Access Compliance Report

Public Rights-of-Way

(Curb Ramps)

Intersection ID: 10014702	Main Street: PERIWINKLE_HILL_CT	Cross Street: N/A	Location: E
ADA ID: FB6671DFFF05	Ramp Type: BlendTrans1	Initial Pass/Fail: Pass	Overall Compliance: No
Severity Score: 0			
Codes/Mitigation Info/Possible Solution		Field Measurements/Component Compliance

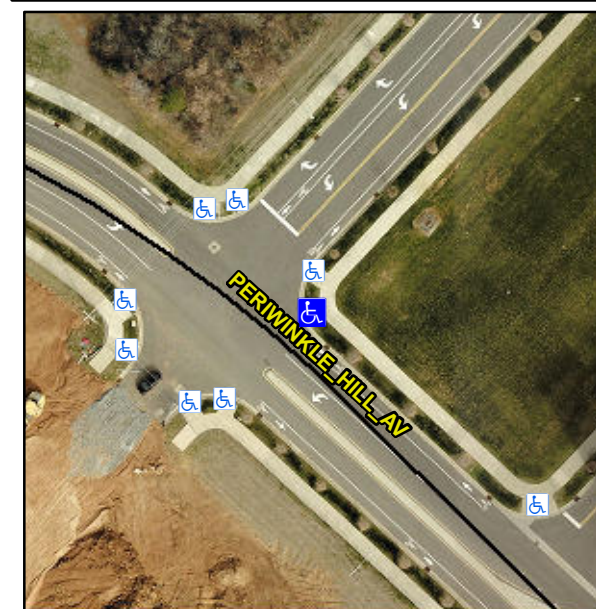
R305.2

Remove & Replace Detectable Warning System.
